SUBJECT: HARBOR FREIGHT TOOLS, RIVERSIDE DRIVE TRANSPORTATION CONCURRENCY REVIEW (PL2017-009)

The following review comments describe the transportation concurrency analysis for the Harbor Freight Tools development at 2400 Riverside Drive in Mount Vernon, WA.

Figure 2. Preliminary Site Plan

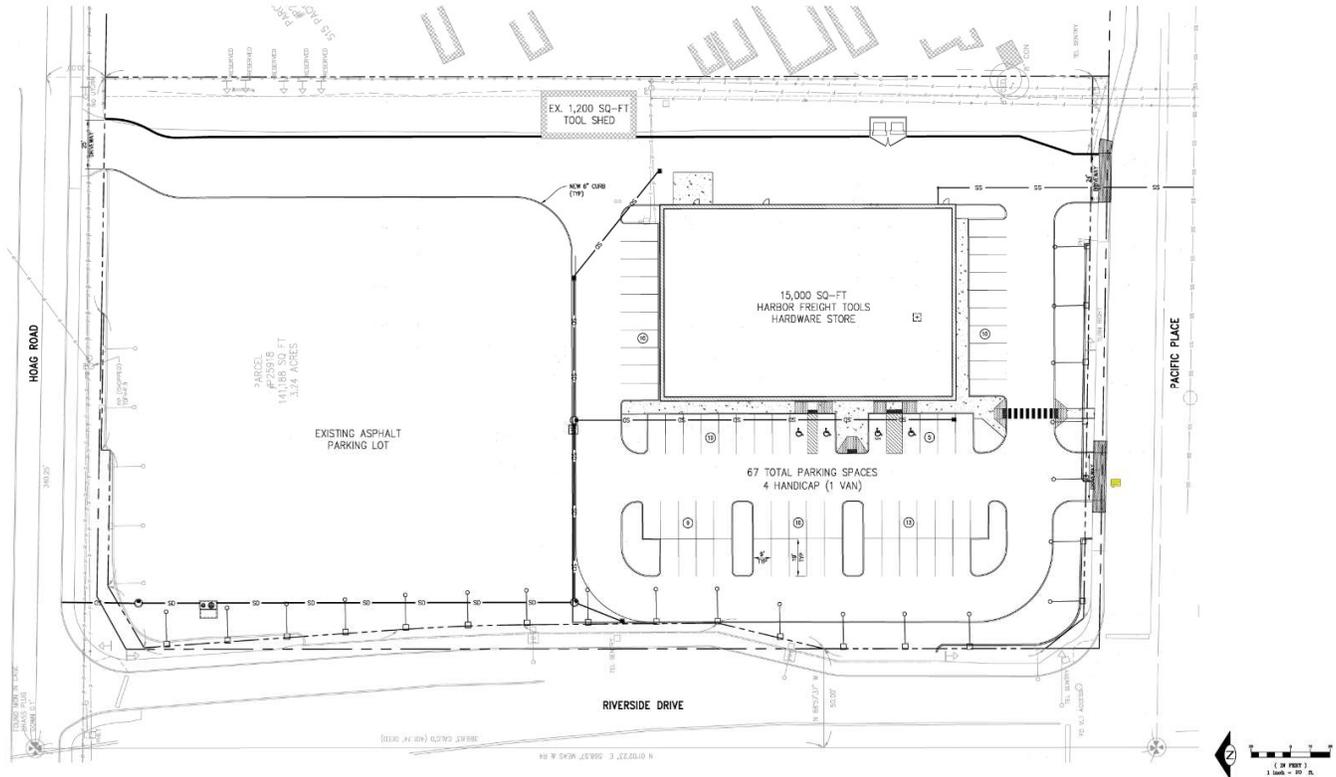
Site access is proposed via two existing driveways on Pacific Place and one existing driveway on Hoag Road, as shown in Figure 2. The existing Pacific Place site accesses are located 35 and 185 feet (tangent curb length) from the intersection at Riverside Drive.

The curb ramp on the northeast corner of the intersection of Riverside Drive and Pacific Place at the project frontage does not appear to satisfy current ADA standards. The applicant should improve this curb ramp as necessary to satisfy ADA standards.

D. On-Site LOS: Site access is proposed via three existing driveways: two on Pacific Place to the south and one on Hoag Road to the north of the project. The west site access on Pacific Place is located 35 feet from the Pacific Place & Riverside Drive intersection, as measured by the curb tangent length.

To provide adequate corner clearance, the minimum tangent curb length between the nearest edge of a driveway on an intersecting side street and an arterial / collector street, or a driveway on an arterial / collector street and an intersection with a cross street shall be 50 feet.

The west site access on Pacific Place does not meet the City’s minimum spacing requirement. The City may restrict or prohibit site access from this driveway.

- Harbor Freight Tools transportation impact fee is \$45,144.
- The west Pacific Place driveway will be restricted to right-in-right-out access.
- The applicant will improve the curb ramp on the northeast corner of the intersection of Riverside Drive and Pacific Place, if necessary, to satisfy ADA standards.
- ADA standards must also be satisfied at all site accesses, adjacent sidewalks, and on-site transportation facilities.

Figure 3. Harbor Freight Tools PM Peak Hour Vehicle Trip Distribution

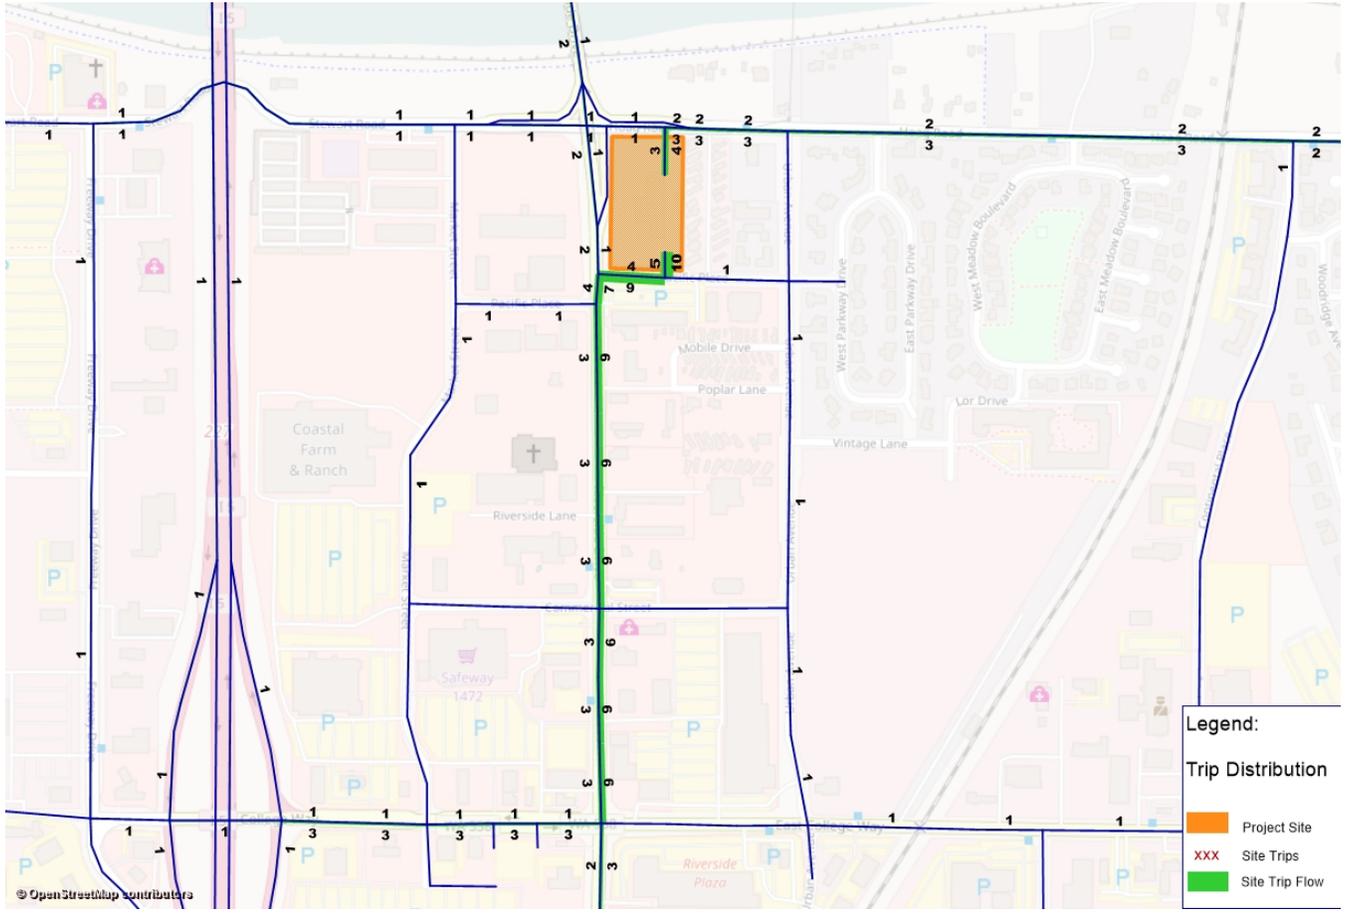
The concurrency model calculated the trip distribution and assignment shown in Figure 3. The majority of project-generated trips will travel to and from the site via Riverside Drive to the south or via Hoag Road to the east of the site. No other street segment will experience more than four project-generated trips during PM peak hour.

B. Traffic Capacity LOS: Intersections and segments affected by project-generated trips have been evaluated for traffic capacity LOS. A total of 22 net new project-generated trips are added to the network. As shown in Figure 3, most project-generated trips access the site via Riverside Drive to the south of the site or Hoag Road to the east of the site.
